Access Compliance Report

Public Rights-of-Way

(Curb Ramps)

| Intersection ID: 43839 | Main Street: DELUCA_DR | Cross Street: HAMEL_ST | Location: SW |

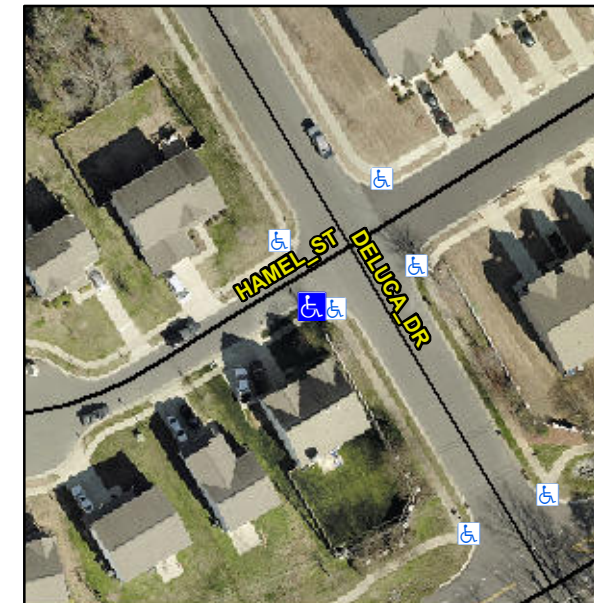
Not Found, R304.2.2

| Compliance | Description | Data | Compliance | Description | Data |
|------------|-----------------------|------|------------|-----------------------------|------|
| N/A | Ramp Length (in) | 47.5 | No | Ramp Slope (%) | 9.1 |

Remove & Replace Entire Ramp.
